Office Action Summary

10/551,111

FRANCISQUINI, MELQUISEDEC

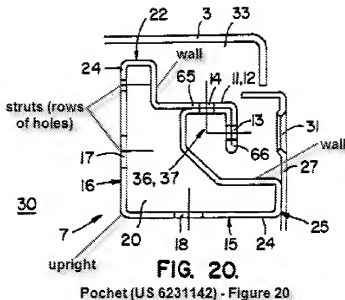
Regarding claim 20, Pochet discloses an improved metallic profile (7: Figure 20) that can be used in the assembly cabinets, enclosures, boxes, or panel boards of an indoor or outdoor type, said cabinet (1: Figure 1) being in the form of a box having side closures (27), including a tilting door (3), an assembly of metallic profiles (Figure 2 shows an assembly of metallic profiles, with Figure 20 being one of the cross-sectional embodiments of the profile) forming a structure which, on an outside, support the closures and accessories (Figures 1 and 20), while on the inside, has struts (17, 18, see annotated Figure 20) capable of being for the assembly of electric and electronic components and devices, the metallic profile comprising a cross section (Figure 20) made from a metallic sheet (Column 5 Lines 54-56) which represents a transversal cross section with a defined triangular rectangular geometry, having a side which forms an inner section or a central core of a tubular form (Column 5 Lines 54-56), an upright (see annotated Figure 20) facing an inside (30) of a cabinet (Column 6 Line 31), an

opposite upright (65) facing an outside of the cabinet, two adjacent uprights (24) having walls (15,16) which form a right angle, the walls forming each upright being first perpendicularly folded in a direction of the upright (the opposing upright:65), and then folded inwards to form an apex having a "U" shape (22, 25), the walls (15,16, and see annotated Figure 20) stretched and folded at different angles such that the walls have ends located one against the other, superimposing on one another so as to form the opposing upright, the cross section being closed and extended outwardly for configuration as an assembly wing (11,12) flanked by the two walls which remain outside the cabinet, the walls (15,16) remaining inside the cabinet and having rows of openings and holes (Examiner interprets these to be the same as the struts mentioned previously in the claim: 17,18, annotated Figure 20) with variable sizes which constitute fastening points that can be used for different components mountable in the interior of the cabinet, the mounting wing (Examiner interprets to be the assembly wing (11,12) having rows of variable openings and holes (13,14: the holes are variable in that they are oriented in different directions) that can be used for fastening external components to the cabinet.

Regarding claim 21, Pochet, as modified by Bales and Debus, discloses the metallic profile wherein the uprights (24) and the upright (the opposite upright: 65) are located at an inclined alignment which forms a diagonal to the upright (see annotated Figure 20: located on corner between walls (15 and 16)).

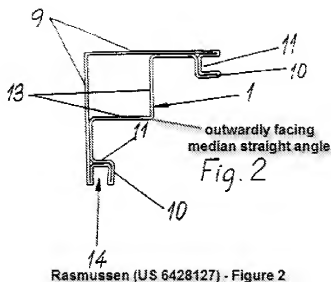
Regarding claim 22, Pochet, as modified by Bales and Debus, discloses the metallic profile wherein the mounting wing (11,12) is positioned parallel in relation to one of the apexes (22) (Figure 20).

Regarding claim 23, Pochet, as modified by Bales and Debus, discloses the metallic profile wherein the mounting wing (11, 12) is positioned parallel in relation to one of the apexes (25), and further extends in conjunction with a fold at right angles (Figure 20).

Regarding claim 24, Pochet, as modified by Bales and Debus, discloses the metallic profile wherein a diagonal wall interlinking two apexes (22,25) which are straight and in a mid part thereof, two steel sheets face outwards, forming the double mounting wing (11,12).
